# UNITED STATES PATENT AND TRADEMARK OFFICE

APPLICATION NO.	FILING DATE	FIRST NAMED INVENTOR	ATTORNEY DOCKET NO.	CONFIRMATION NO.
10/536,653	05/30/2006	Christian Kranz	1890-0242	9076

## Office Action Summary

**DETAILED ACTION**

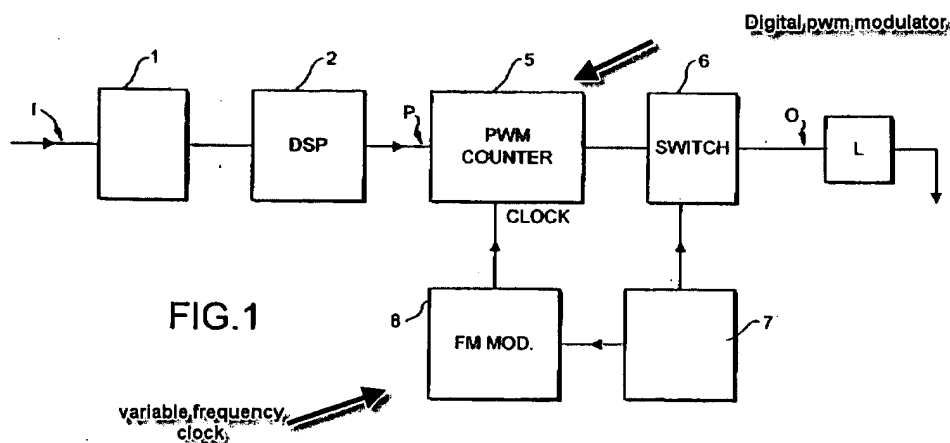
Claim 1 is rejected under 35 U.S.C. 102(b) as being clearly anticipated by Newey US 6,124,757 of record (Newey).

Figure 1 and the relevant text of Newey discloses a method for the correction of signal distortions in an amplifier device where the steps of operating a digital PWM modulator 5 is provided and the step of applying a variable frequency system clock via the element 8 of Newey is provided. Note that the abstract describes the correction of the signal due to the power source.
